**PHRC- Renovation Project 2nd Floor Suite
Columbia, South Carolina
University Project Number FP00000192**

January 18, 2019

ADDENDUM No. 2

PROJECT NUMBER
 SHEET NUMBER
FP101
 SHEET NAME
SECOND FLOOR PLANS
 DATE 12.20.18

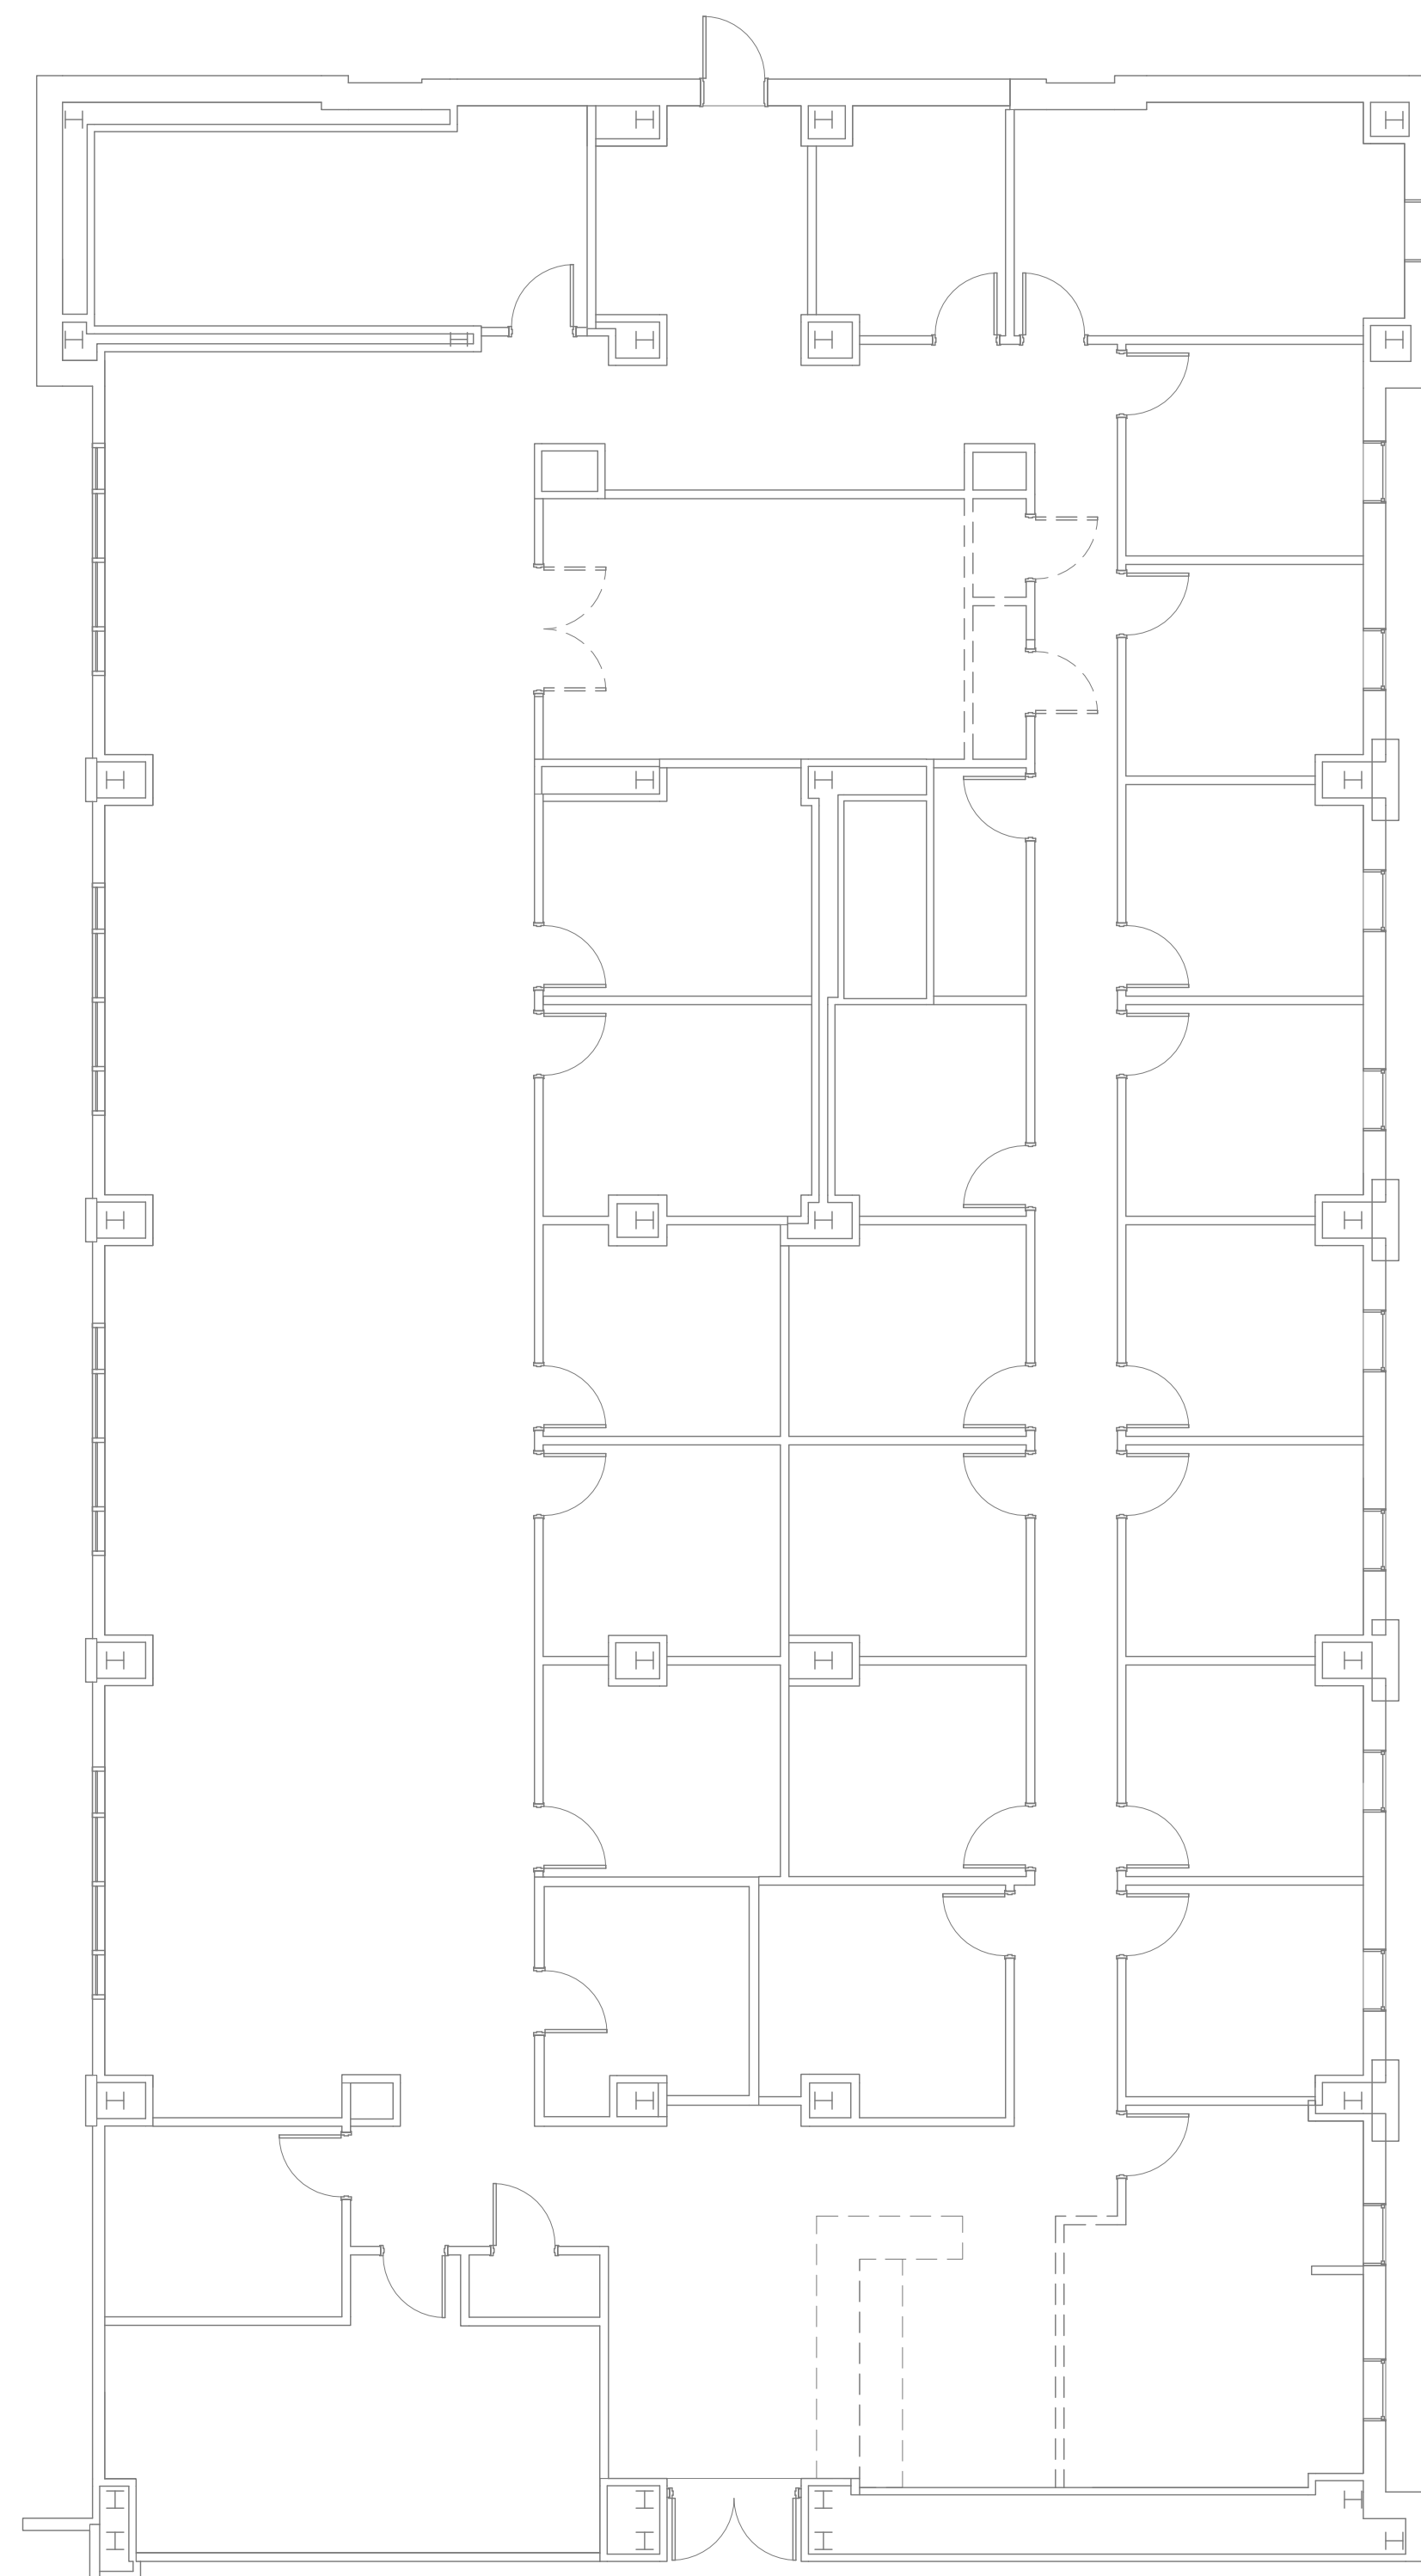
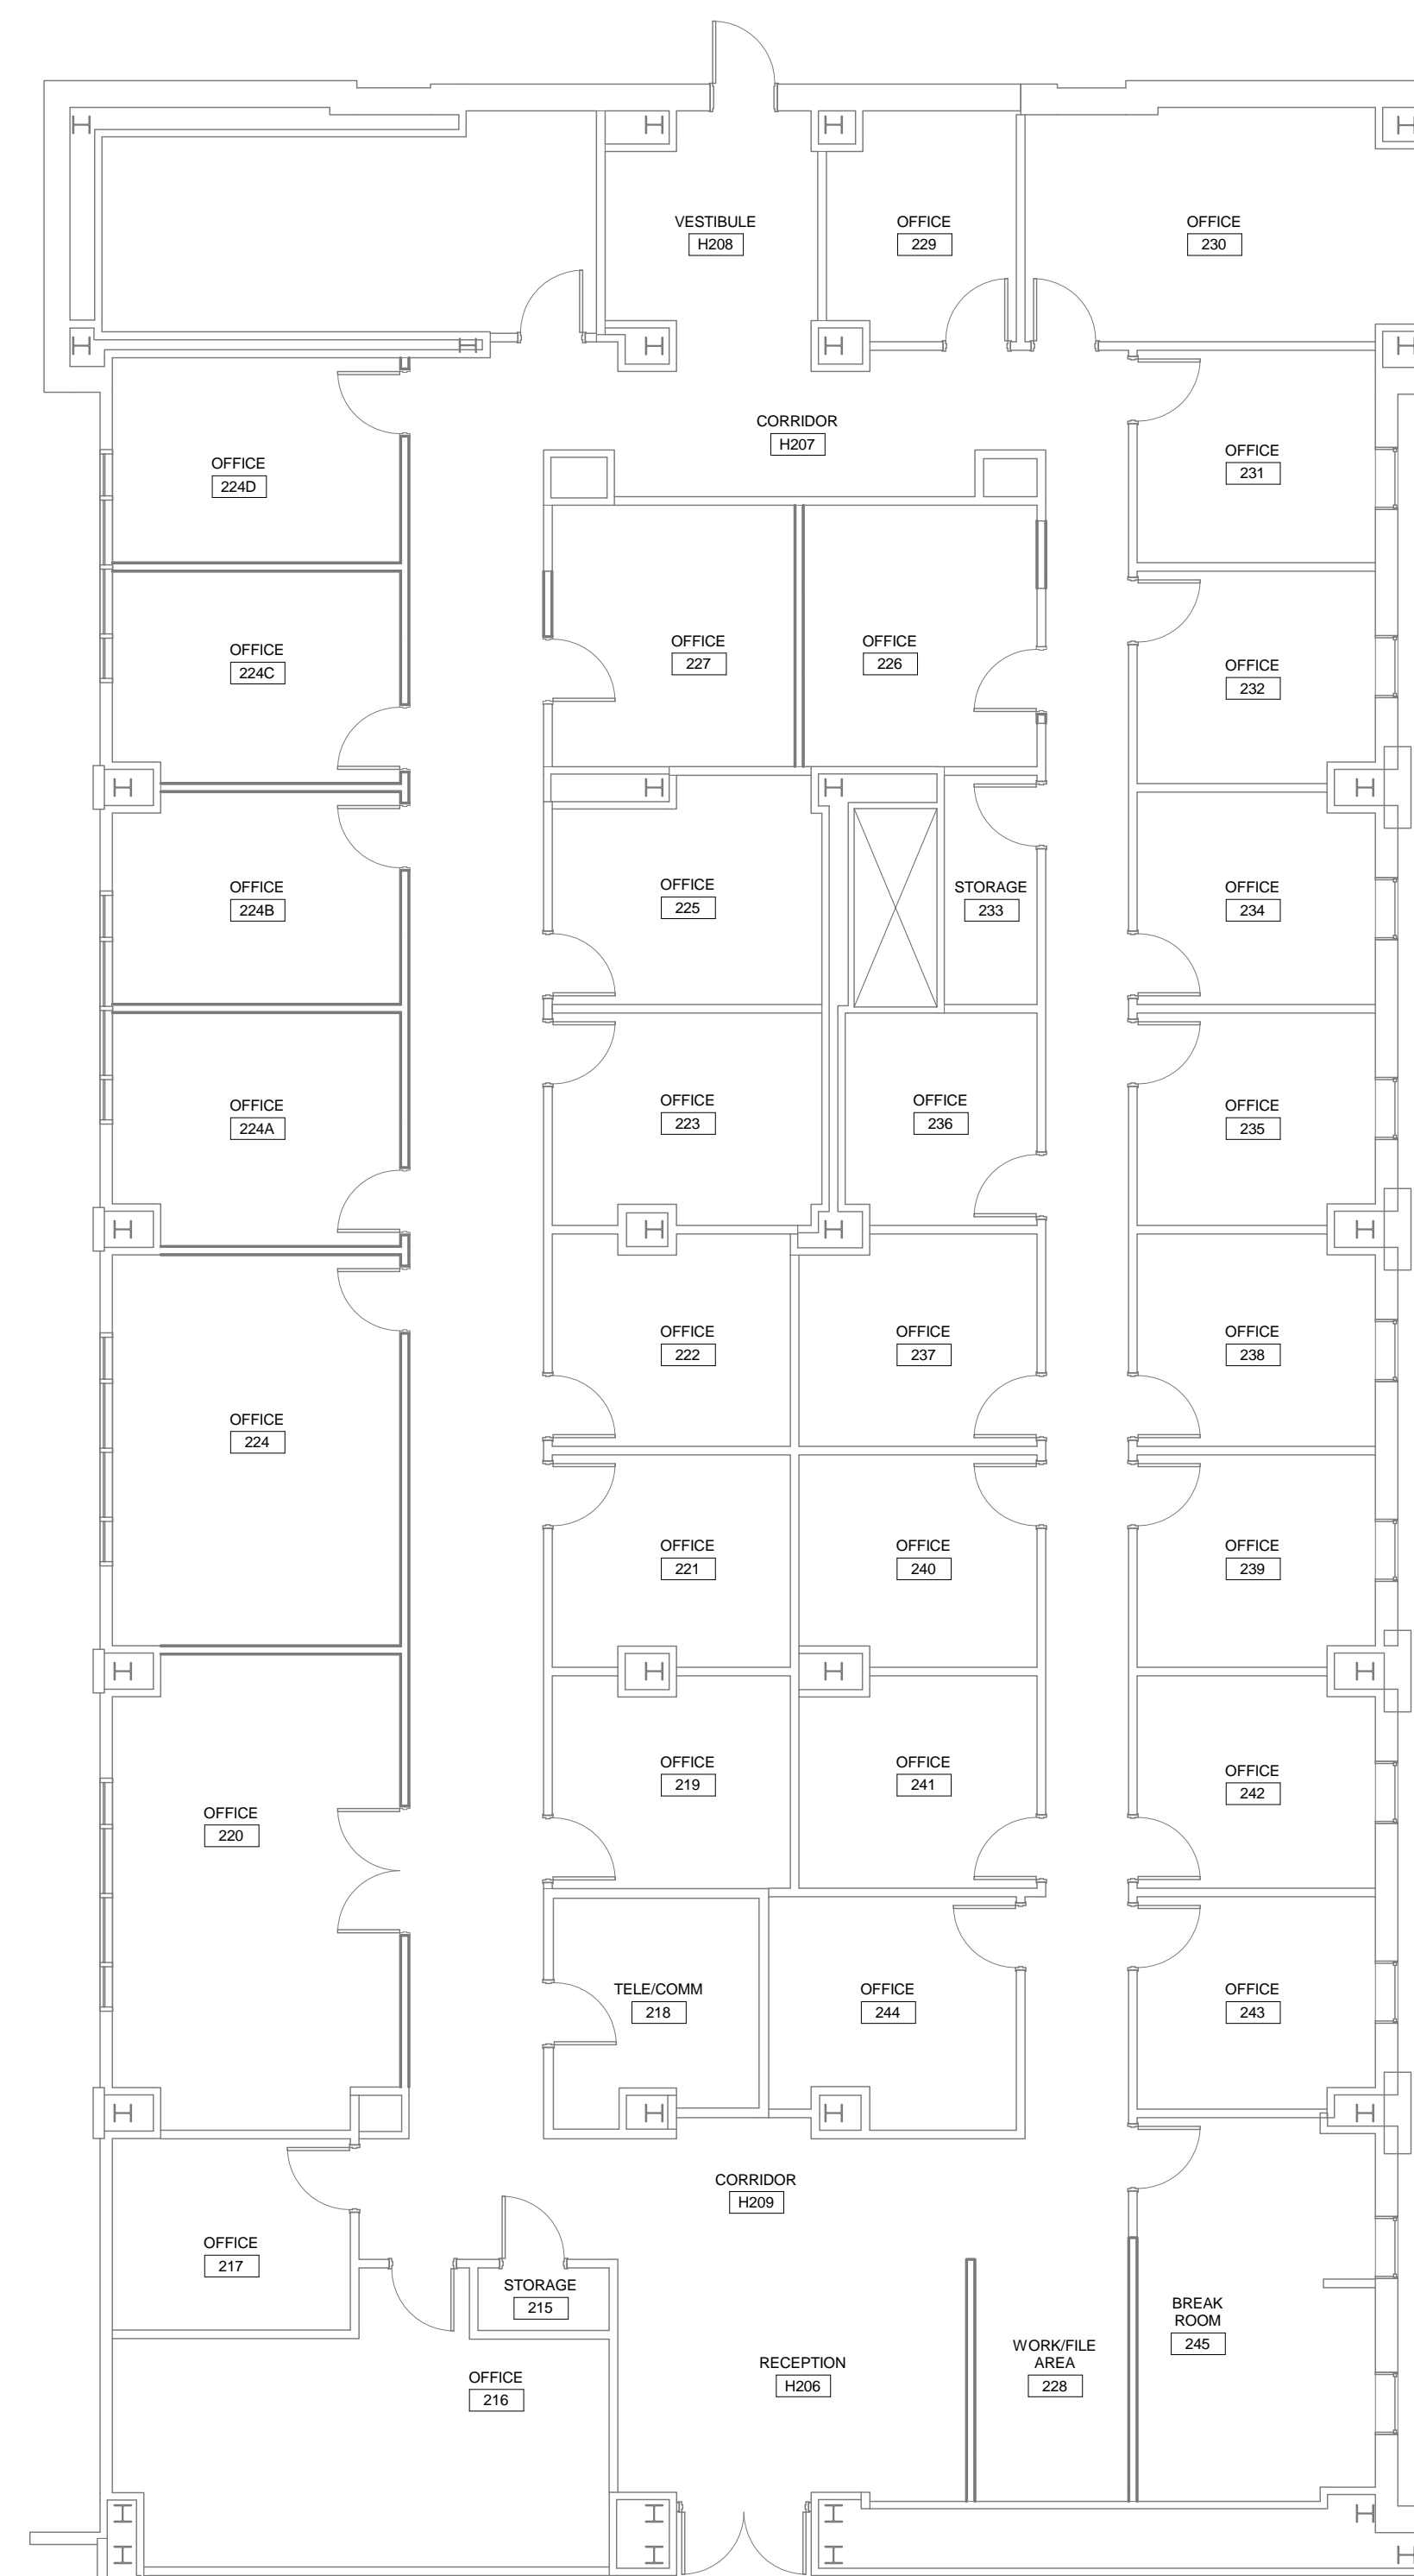
1. Reference Sheet A801, dated 12.20.18: DELETE Sheet and ADD in its place Sheet A801, dated 12.20.18, revised 01.18.19, attached.
 - a. Clarifications to DOOR SCHEDULE.
 - b. Clarifications to FRAME TYPES.
 - c. Clarifications to GENERAL INTERIOR FINISH NOTES.
2. ADD Sheet FP 101, dated 12.20.18, revised 1-18-19, attached.
 - a. Clarifications to Fire Protection.
3. Reference Sheet CVR, dated 12.20.18: DELETE Sheet and ADD in its place Sheet CVR, dated 12.20.18, revised 01.18.19, attached.
 - a. Clarifications to DRAWING LIST.

1. Where is the scope of the sprinkler work indicated?
 - a. See MODIFICATIONS TO DRAWINGS, this Addendum.
2. Please establish a number of ceiling tiles to be replaced by when rearranging sprinkler heads, light fixtures and HVAC ceiling registers.
 - a. The General Contractor shall determine the number of ceiling tiles to be replaced by the scope of work required to complete the Project. For Bidding purposes only, contractors shall assume 50 ceiling tiles will need to be replaced (to match existing base building ceiling panels).
3. How many sprinkler heads will be required to move?

PROJECT SCOPE:
 EXISTING SPACE IS COMPLETELY PROTECTED BY A NFPA 13 COMPLIANT SYSTEM. CONTRACTOR SHALL REVISE SYSTEM AS REQUIRED TO ACCOMMODATE NEW WALLS AND CEILING. SEE ARCHITECTURAL PLANS. COMPLETED SYSTEM SHALL BE IN COMPLIANCE WITH NFPA 13 - 2013 EDITION AND THE INTERNATIONAL FIRE CODE - 2015 EDITION. ALL SPACES WHERE WORK IS TO BE DONE ARE TO BE CONSIDERED LIGHT HAZARD.
